Apprentice 3 2-Pole Relay Installation Details

Figure A. AP3-4 panel H.V. Barrier

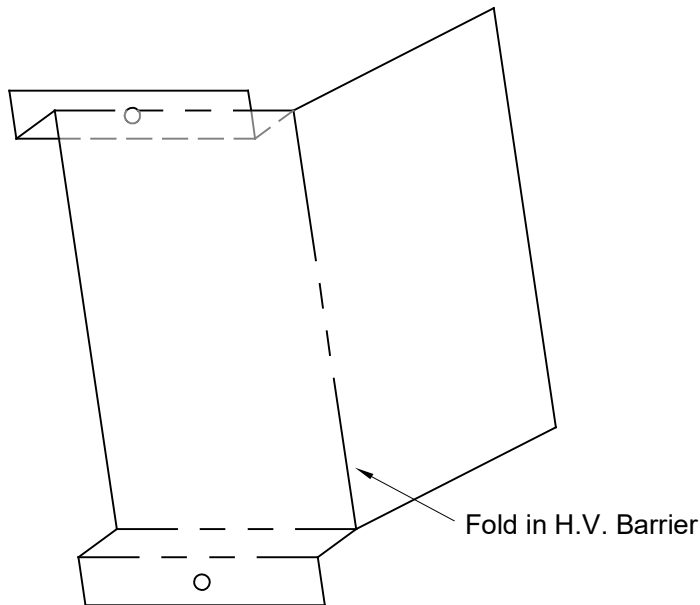
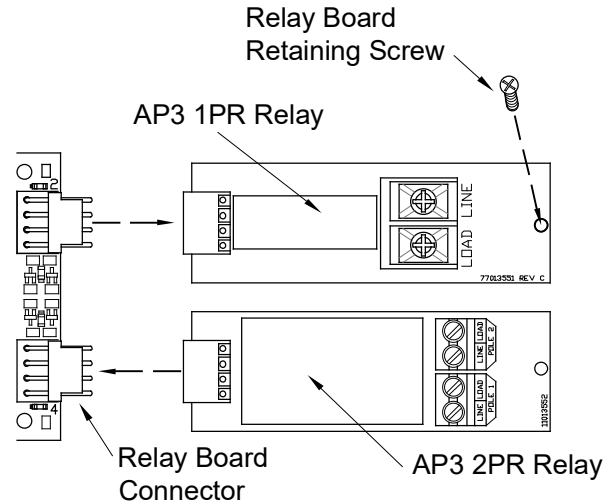
When Installing a 2PR relay in the Apprentice 3 panel you are required to also change the high voltage barrier to accommodate the high of the 2PR Relay. This High Voltage Barrier is required to comply with the panels UL listing.

Figure A, Barrier for AP3-4 panels, 1 required for every 2 relays. Order part #78001567

* Note: The High Voltage Barriers in the panel need to be replaced with the installation of the 2PR (2-pole) relay. Order part number 78001567 for the 4 size panel barrier or 78001568 for the 8, 16, 24 and 32 size panel barrier.

Figure B. AP3-8,16, 24, 32 panel H.V. Barrier

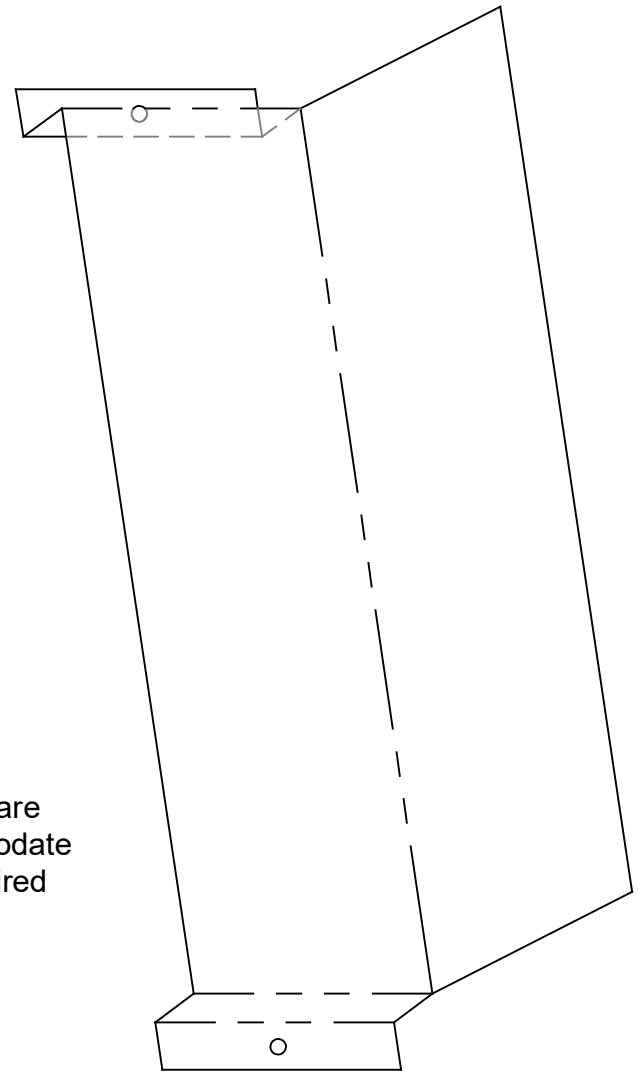
Figure B, Barrier for AP3-8,16, 24, 32 panels, 1 required for every 4 relays. Order part #78001568
